REMEDIAL ACTION WORK PLAN FINAL DESIGN ANALYSIS FOR SUBMISSION REMEDIAL
ACTION AT OPERABLE UNIT 6 (OU 6) SITE 3 AND SITE 10 VOLUME 3 OF 3 NWS EARLE
NJ
7/1/2002
FOSTER WHEELER ENVIRONMENTAL CORPORATION

FINAL Soil Erosion and Sediment Control Plan for Submission Remedial Action at Operable Unit 6 (Sites 3 and 10)

This letter serves to address the items mentioned in the Freehold Soil Conservation District's (FSCD's), "Initial Review Letter", dated September 21, 2001. Further, this letter serves to transmit information and supporting documentation regarding a design modification made to the proposed drainage swales located on the eastern and western sides as well as the interior of the landfill area at Site 3. For ease of review of this letter, the FSCD comment as written in the September 21, 2001 letter, are repeated in italics, followed by the Department of the Navy's response.

TURBIDITY BARRIER
N.T.S.

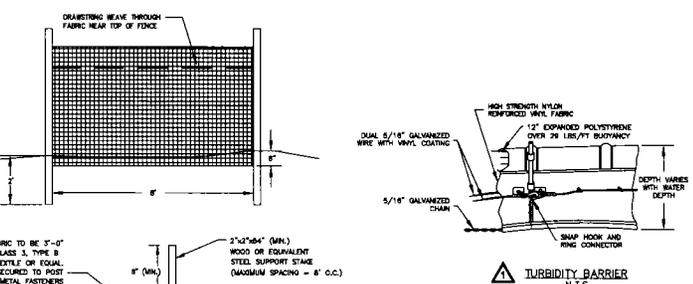
"4. Provide turbidity barrier detail."

As discussed during our last telephone conversation, there are no brooks, streams, rivers or other water bodies subject to flowing water conditions located on Site 3. Therefore, the need for a turbidity barrier does not appear to be warranted nor is it proposed for this project. However, if a turbidity barrier is determined to be needed during construction of the project by a FSCD Inspector, a detail for a turbidity barrier is presented on Sheet C-2 of the Revised Soil Erosion and Sediment Control Plans.
